Safety Recall

N232426400 Tailgate May Open Unexpectedly

Release Date: February 2024

6554952

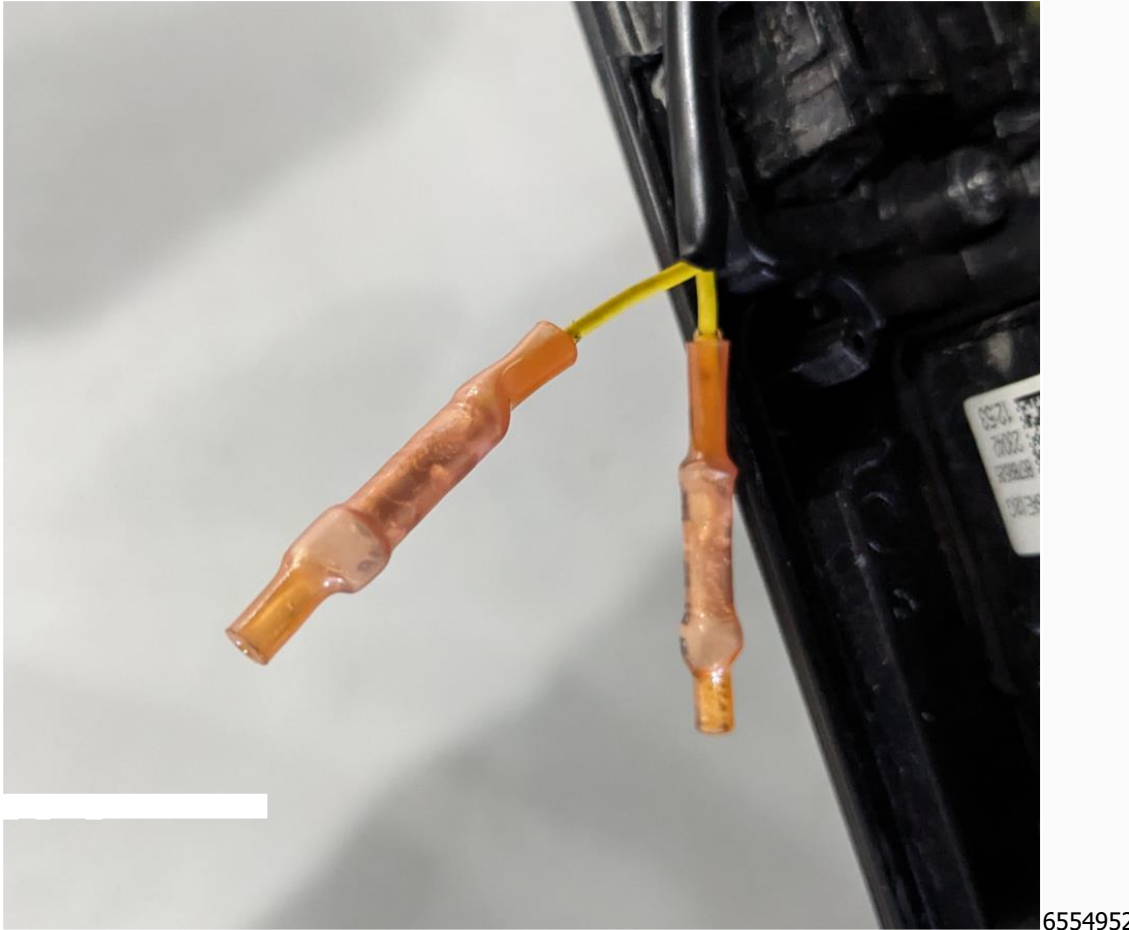
2. Cut the yellow wires close to the switch as shown, being sure to stagger the cuts by at least one inch.
3. Using red duraseal splice sleeves, cover the exposed harness end of both yellow wires.

4. Heat the sleeves until they have shrunk and sealed the wires completely.

6554953

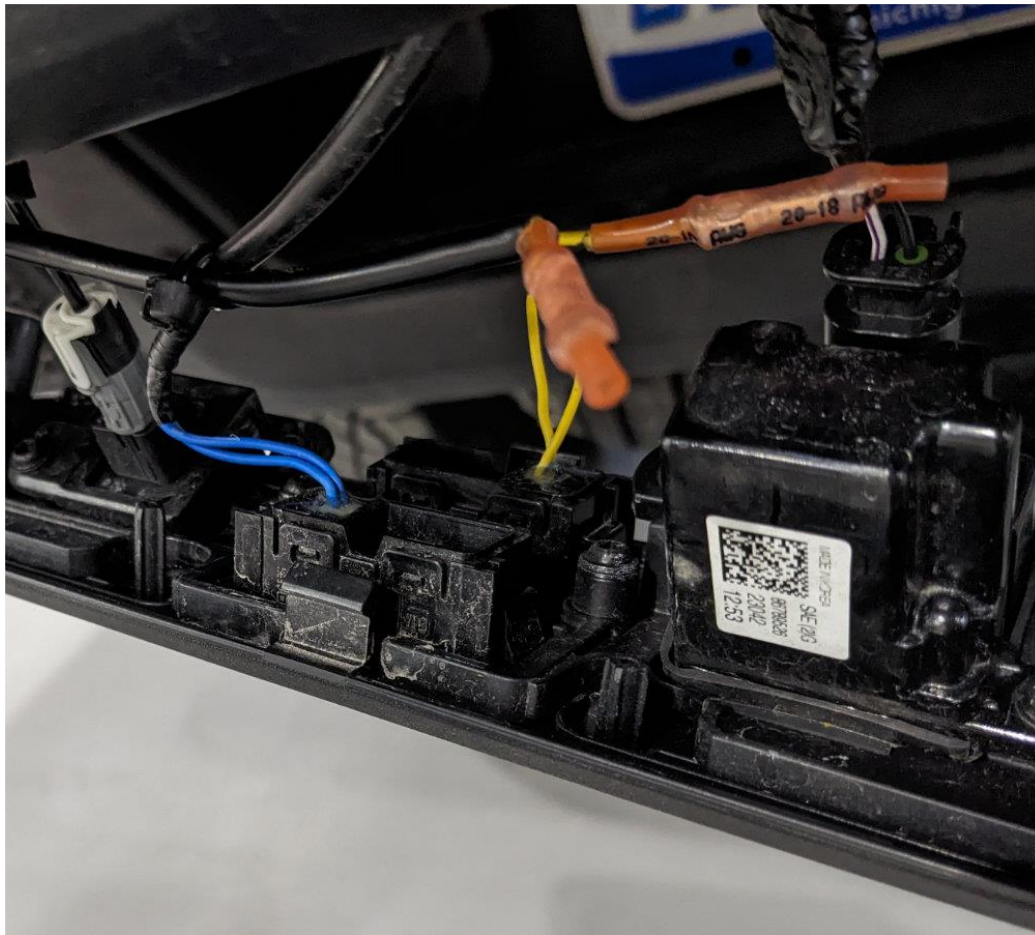
5. (Multi-pro Tailgates Only) Zip tie the yellow harness to the blue harness as shown.
6. Reinstall the Liftgate Exterior Release Switch. Refer to *Liftgate Exterior Release Switch Replacement* in SI.
7. **The Notice to Customer at the end of this bulletin must be provided to the customer for all inventory vehicles sold to customers, and current owner's that had the main liftgate switch disable repair completed. Note: Dealers should also retain a copy for their files.**
